Re:- Construction of New Khattau Makanjee Cloth market in the premises of Trikamdas Gordhandas Khatau, on Plot no 19-20 A.1. Survey Shet No A-15. situate at the junction of Market Road & Newnham Road.

With reference to his letter dated 24th March 1917 regarding building of the new Khattau Wazkanji Market Undersigned has the honour to inform Mr: Jamshedji. P. that he must apply on the printed form herewith attached signed by the owner. The position of the windows below the corrugated roofs must be shown on the 2nd floor plan.

— PROPOSED ADDITIONS TO THE KHATAO MAKANJI CLOTH MARKET —

— ELEVATION TO NEWNHAM ROAD —

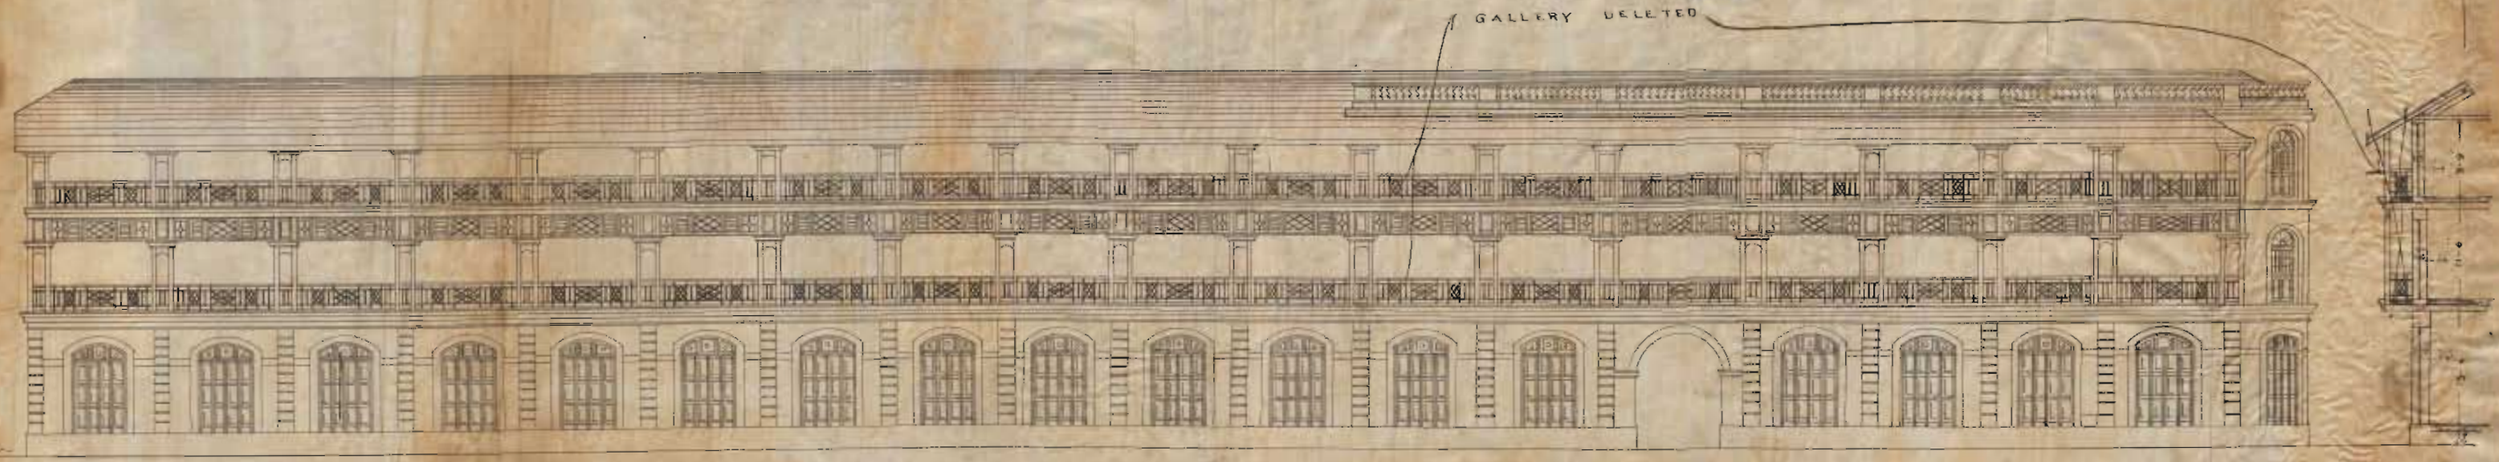
A front elevation of the building must be shown.

(3) Front elevation of the building has been submitted in 2 copies & two more have been sent herewith.

— KHATAO MAKANJI MARKET —
- KARACHI -
— BOUNDARY COLOURED RED —
— CONTAINING (1955) SQR. YDS —
— SCALE 20FT TO 1 INCH —
— NORTH —

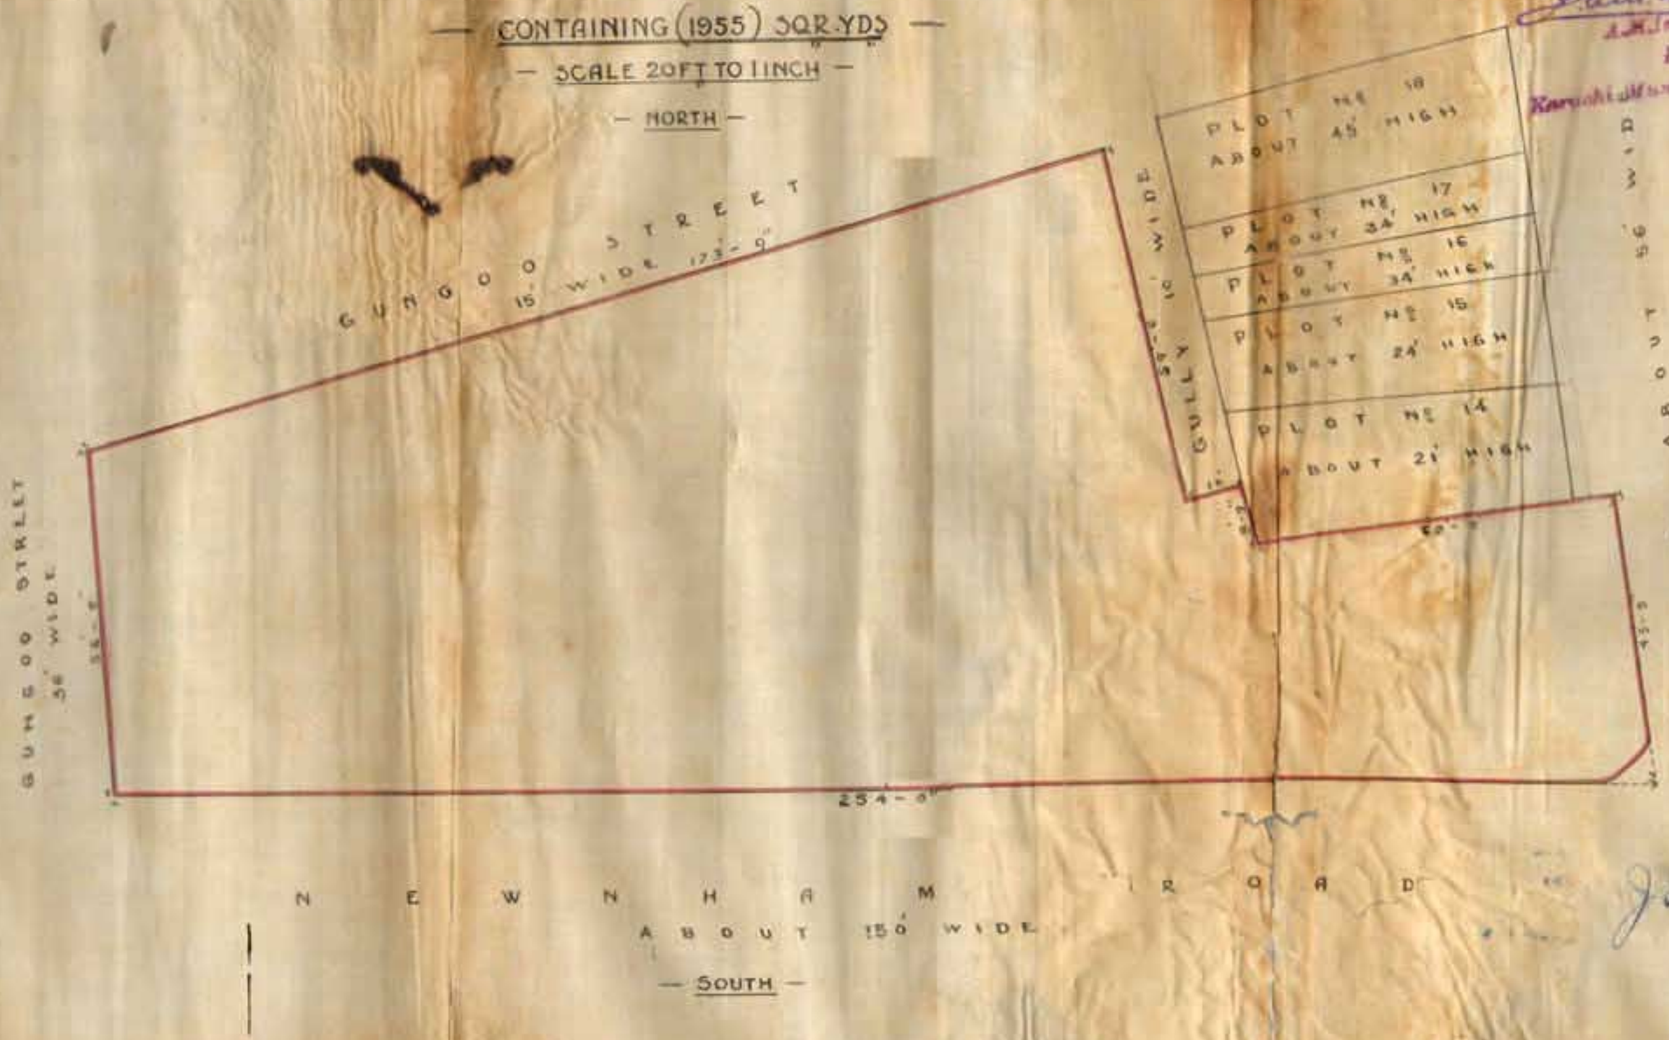
The block plan must be made complete as per particulars copy of which is herewith forwarded.

PLAN of GROUND FLOOR

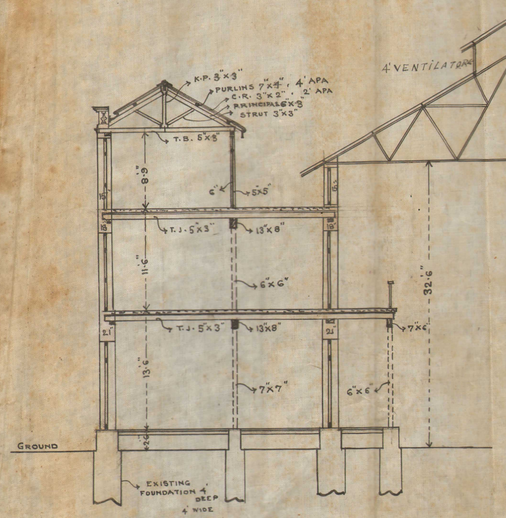
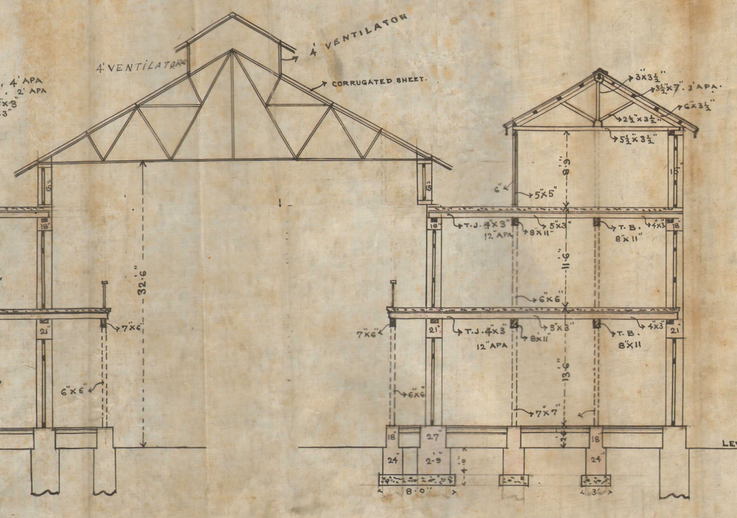
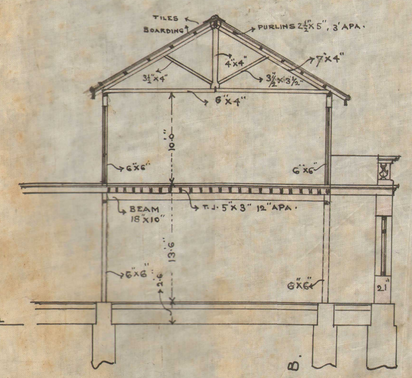
Bath room must be provided on the ground floor separate from the urinals as shown in red & a explained to the architect when he was in office.

Means of ventilation should be shown in the iron roof. Two extra W.Cs. or urinals and one bath room should be provided on the ground floor.

The godown near the W.Cs. on the ground floor must be done away with and the space used for W.Cs. and bath room.

(7) The Godown on the ground floor has been done away with, & three extra urinals and a washing place have been provided therein

PLAN of FIRST FLOOR

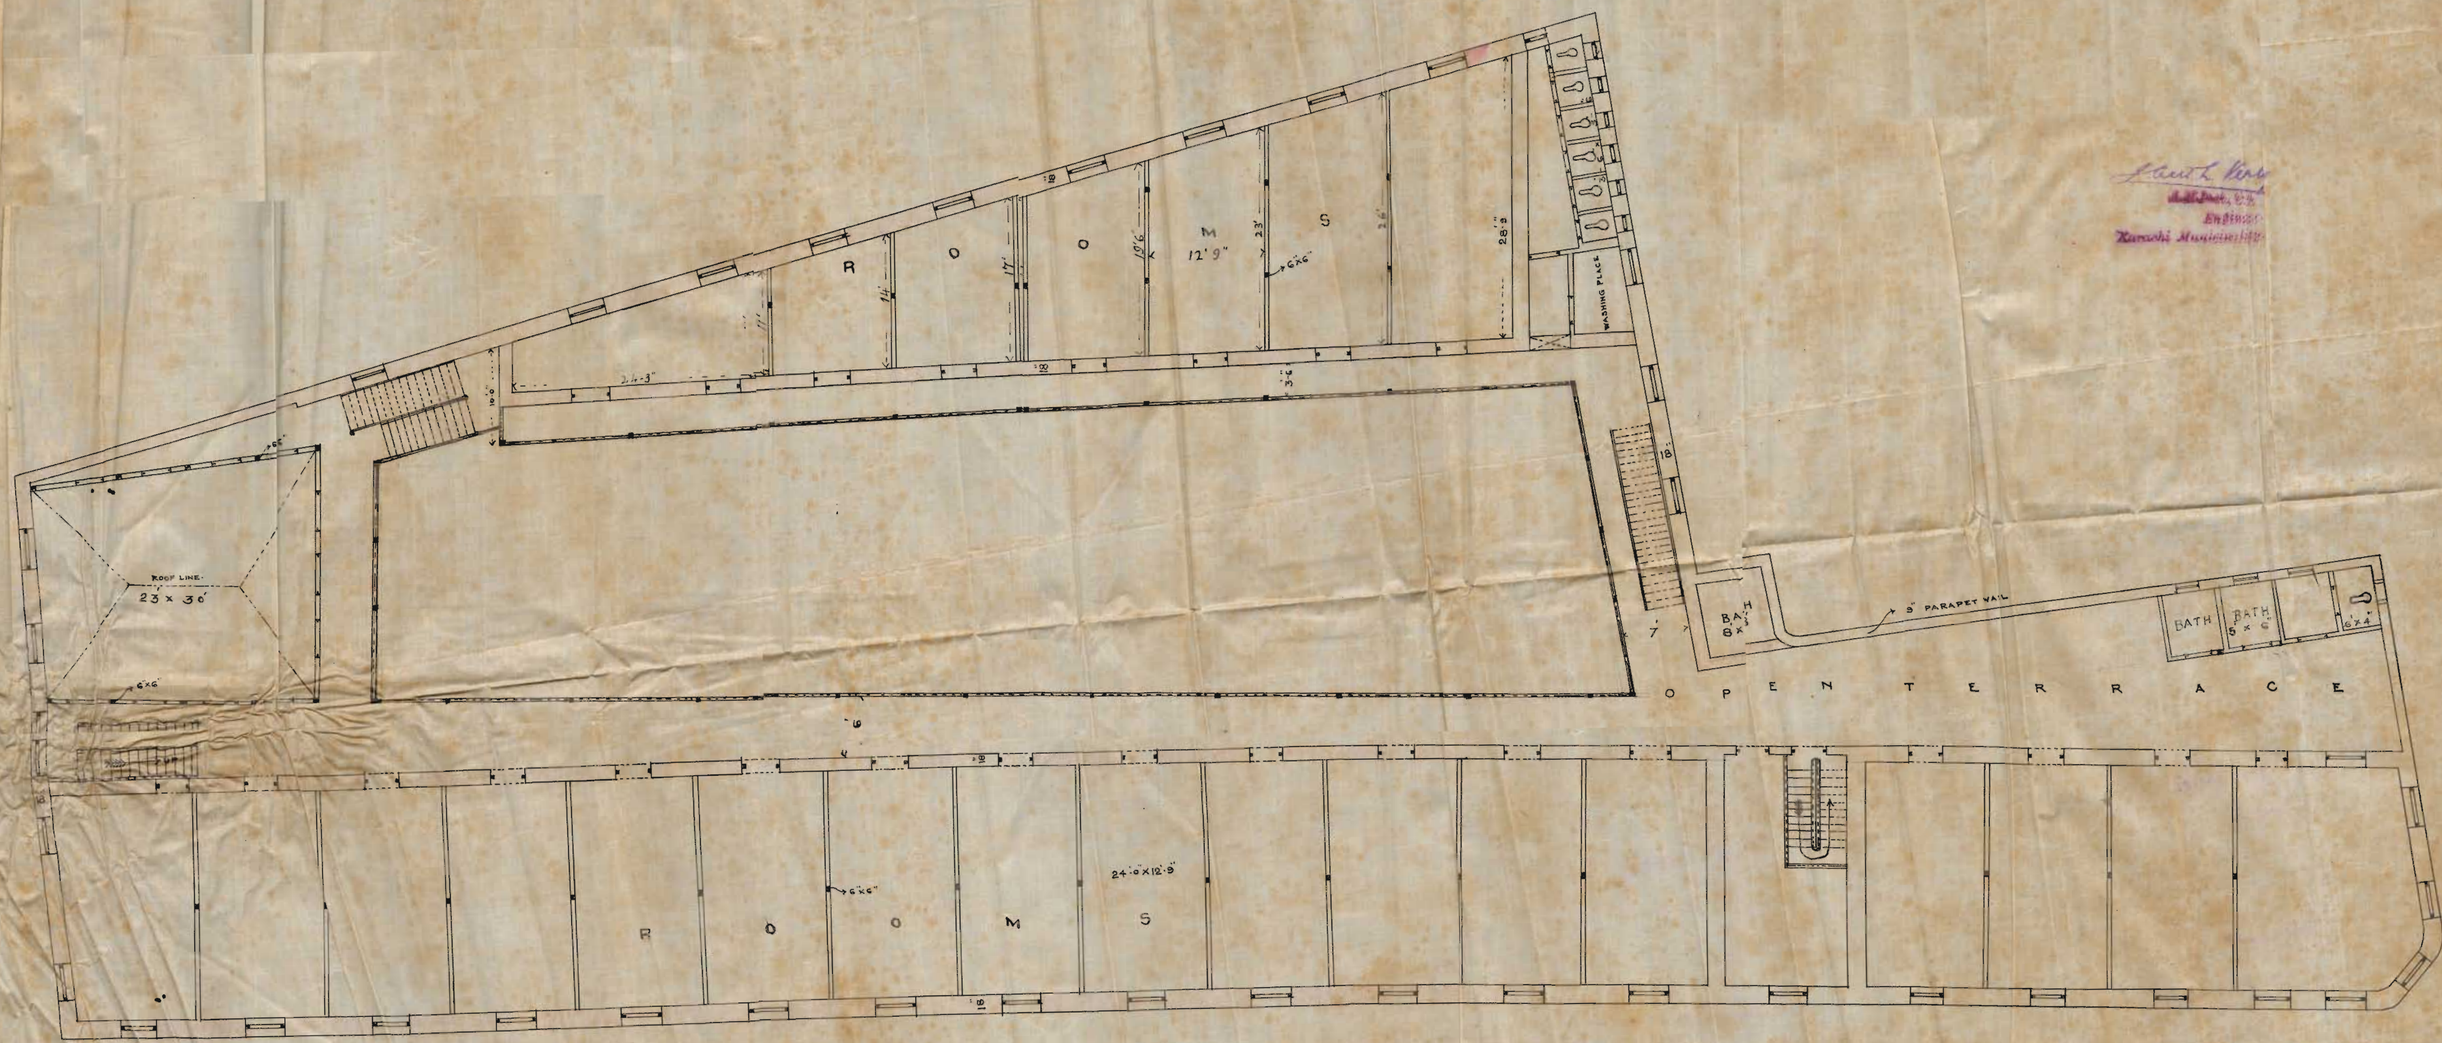
Bath rooms must be provided for the tenants on the 1st floor. It is not shown on the plan for what purpose the rooms on the 2nd floor are to be used. Sanitary conveniences must be provided on this floor.

(8) Additional Bath-rooms have been provided on the first floor.

PLAN of SECOND FLOOR

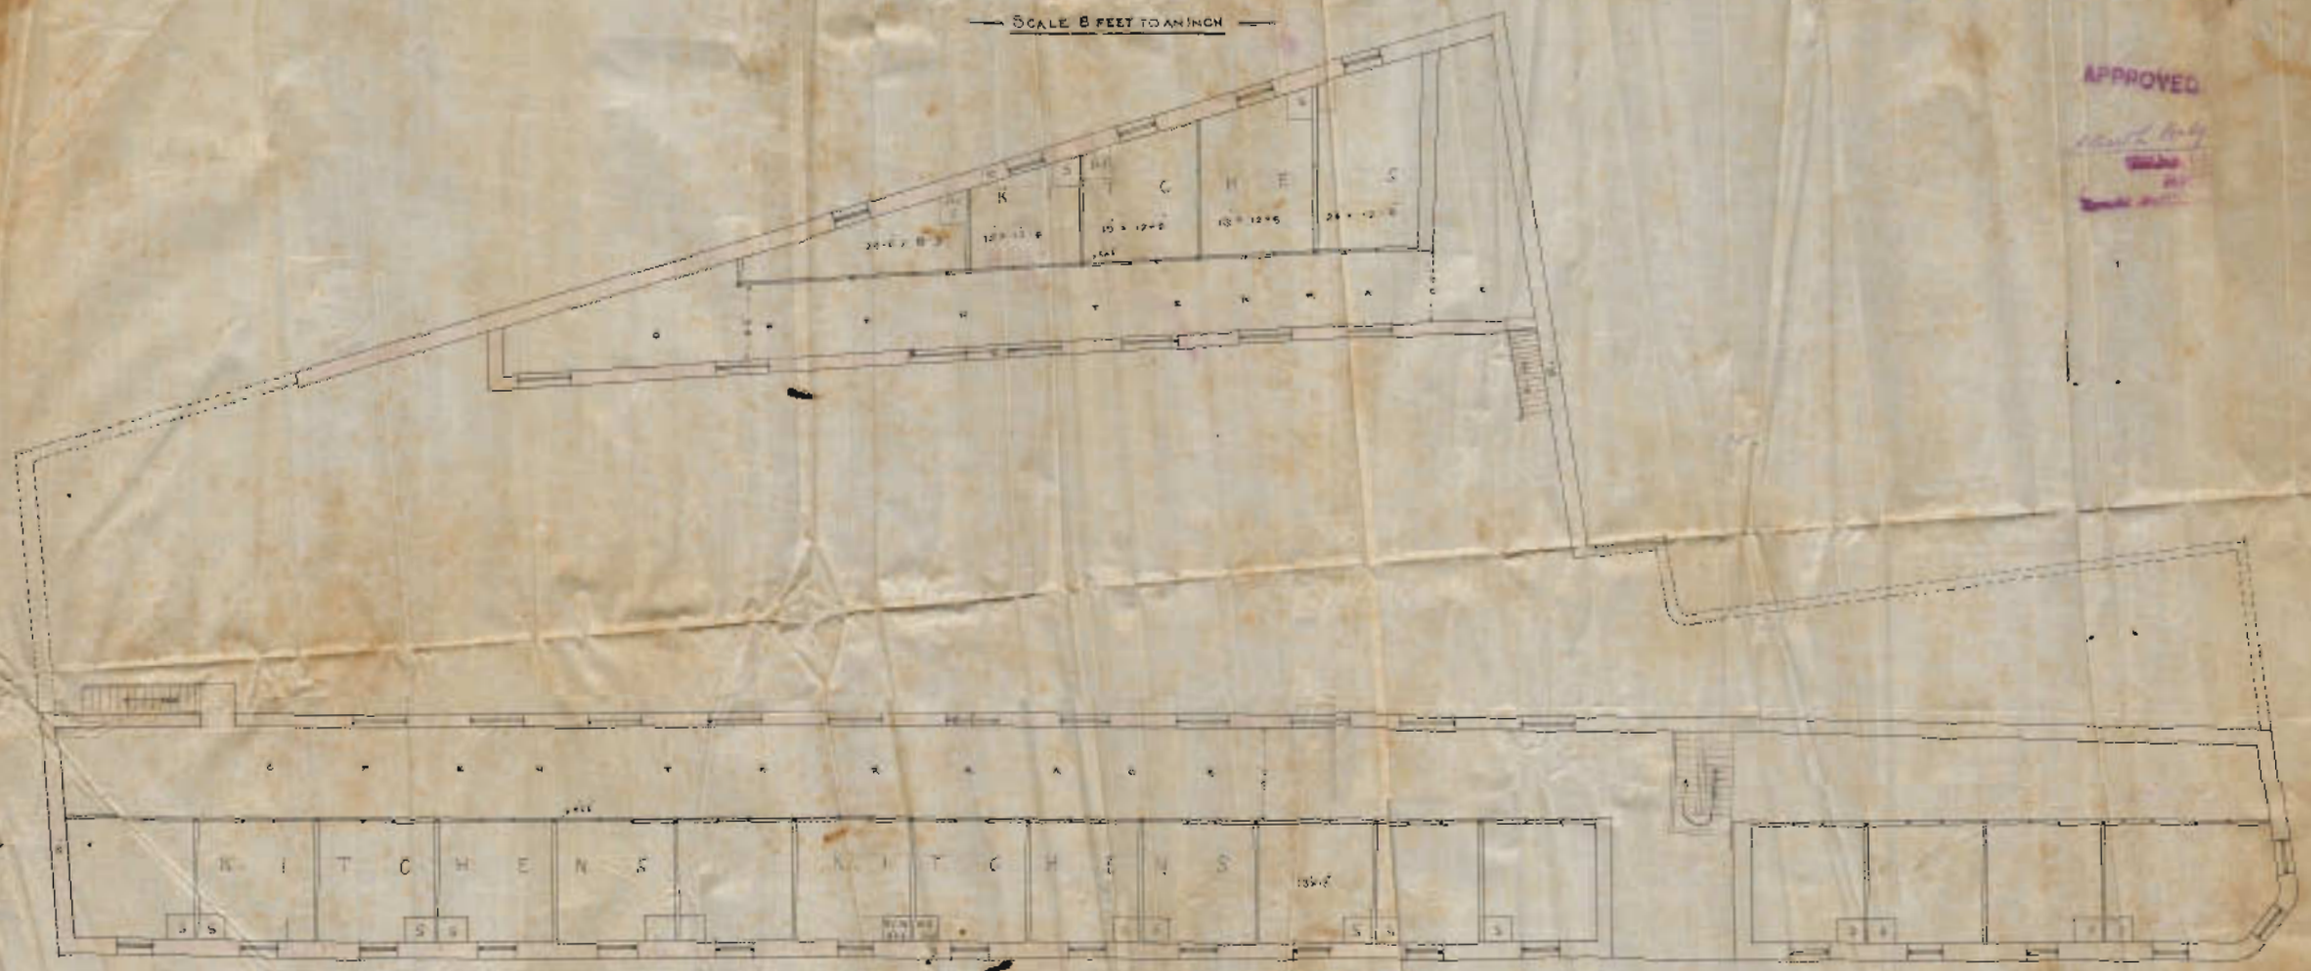
The openings for the staircases are not shown on the 2nd floor plan.

(2) The position of the windows below the corrugated roof has been shown on the 2nd floor plans.

(5) The openings for the staircase are shown on the 2nd floor

(9) The rooms on the 2nd floor will be used as Kitchens only, by the tenants on the 1st floor, & they will be provided with sinks
